Name: St. Mary's Hospital Parking- Revised Final Plan - 7th & Patterson Rd.

REVIEW COMMENTS

ACTIVITY: Revised Final Plan for St. Mary's Hospital Parking Lot

RESPONSE TO CITY REVIEW COMMENTS

FINAL CONDITIONS, DETENTION BASIN RATING

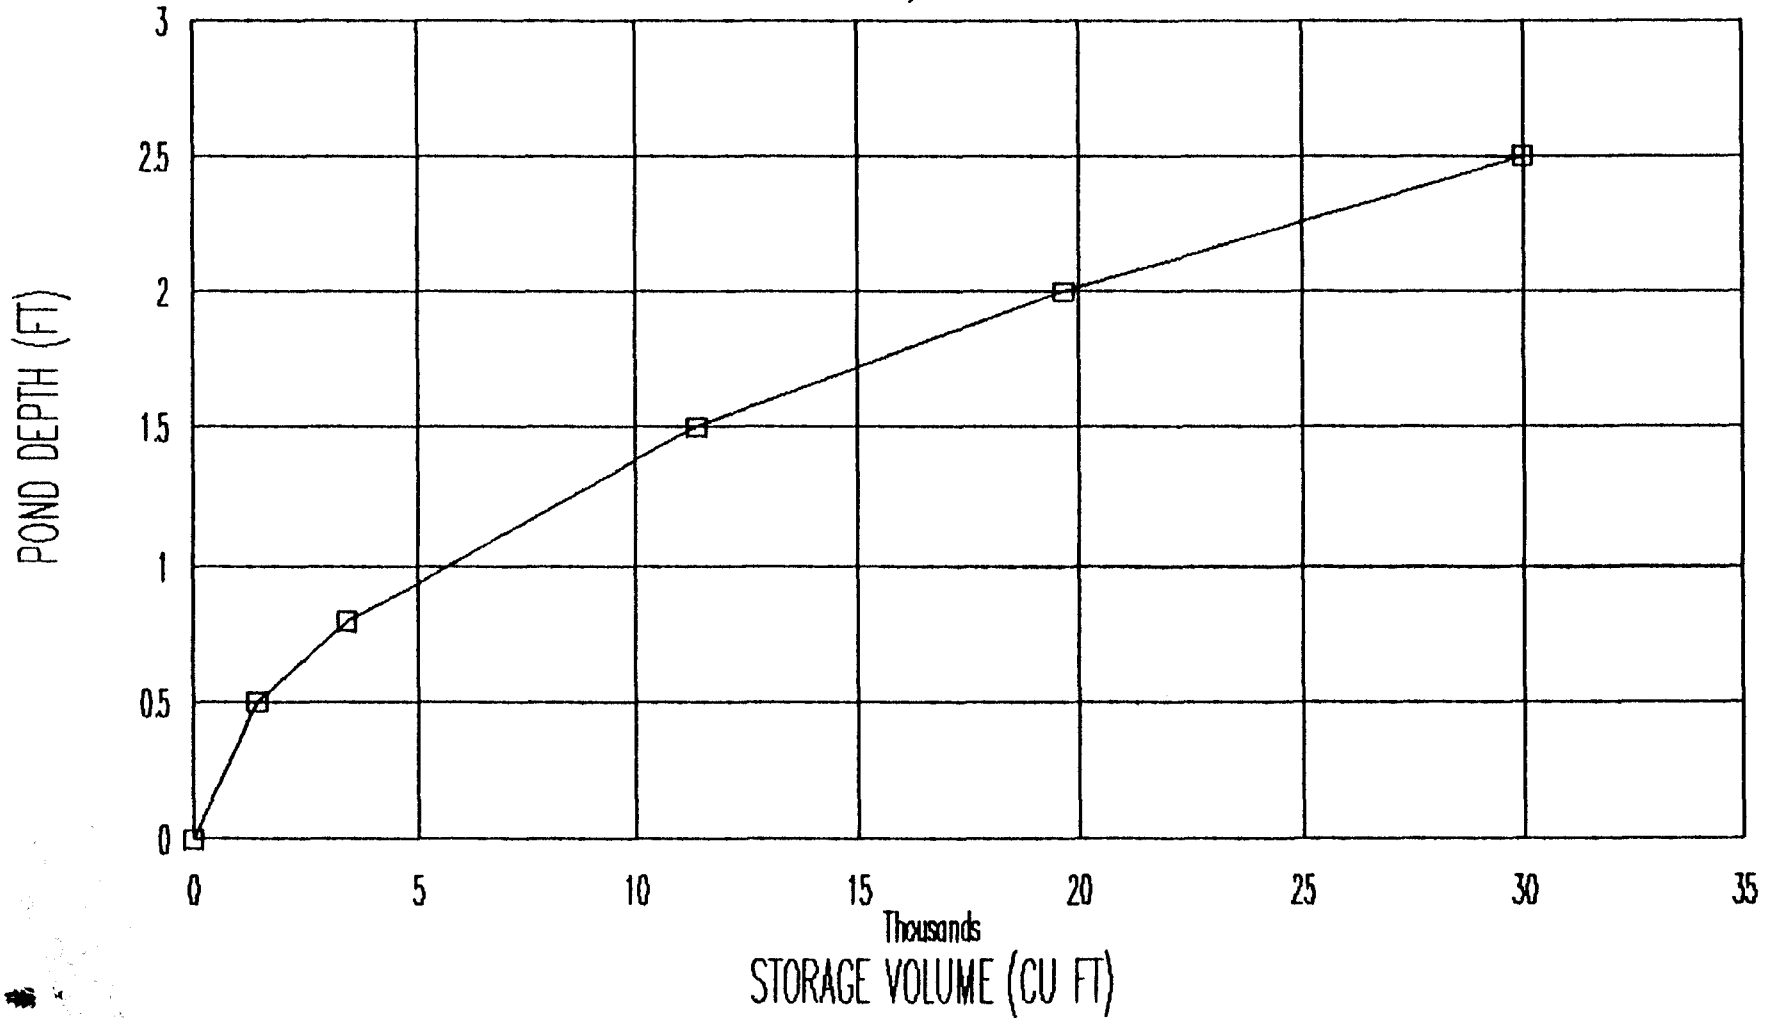
It should also be noted that the final design conditions for the detention pond have changed slightly from the preliminary ones used in the drainage report. Following is a comparison of the two conditions:

PREVIOUS:			FINAL:		
ELEVATION	DEPTH	VOLUME	ELEVATION	DEPTH	VOLUME
38.5	0	0	38.0	0	0
39.0	0.5	1,350	39.0	1.0	2,628
40.0	1.5	11,250	40.0	2.0	11,725
40.5	2.0	19,671	40.8	2.8	27,000
41.0	2.5	30,000
